Re: Sub-Petition No. 1293-BR-03 Amendment - Request for Access Road Modification

**3403 Line - Laminate Structures Project**

Sub-Petition Map Set

Revised Date: October 17, 2022

Mapsheet 2 of 6

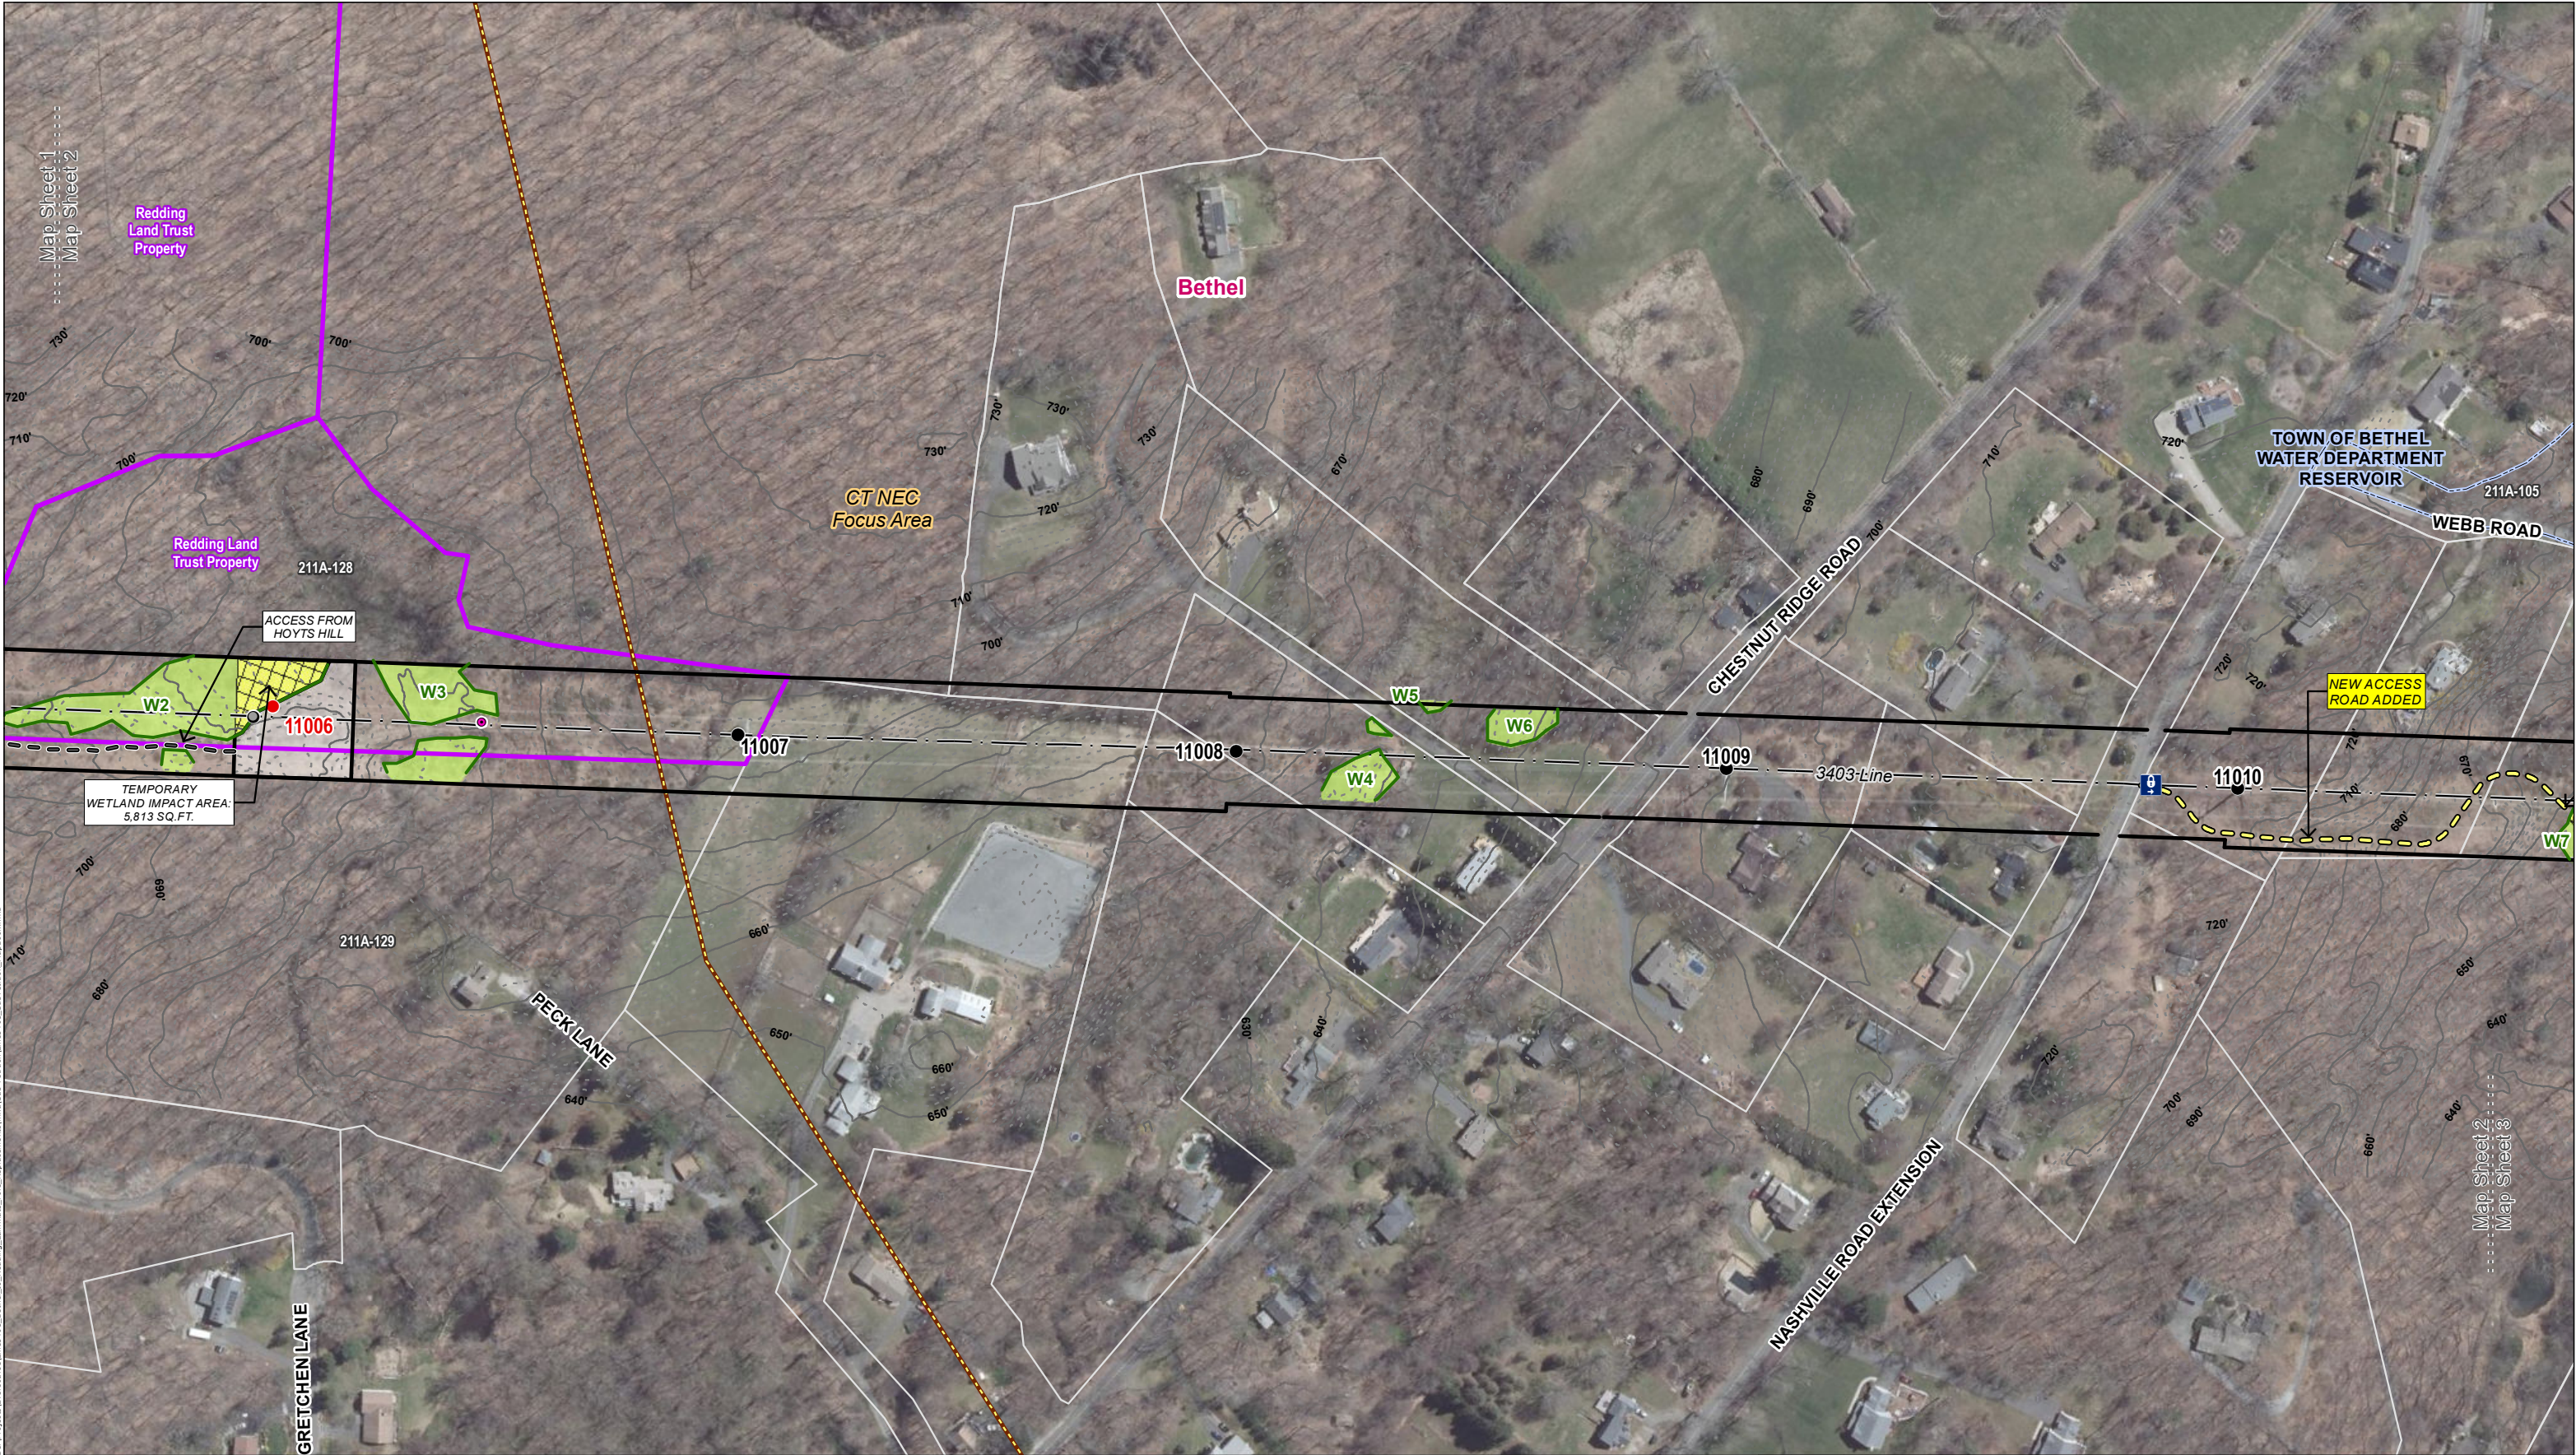
See Attachment A - Revised Sub-Petition Map Sheet 2 and 3 depicting the location of the proposed access west of structure 11011 from Nashville Road Extension.

1	10/17/22	New access road added off of Nashville Road Extension and Str 11011 work pad changed from matting to gravel
NO.	DATE	REVISIONS
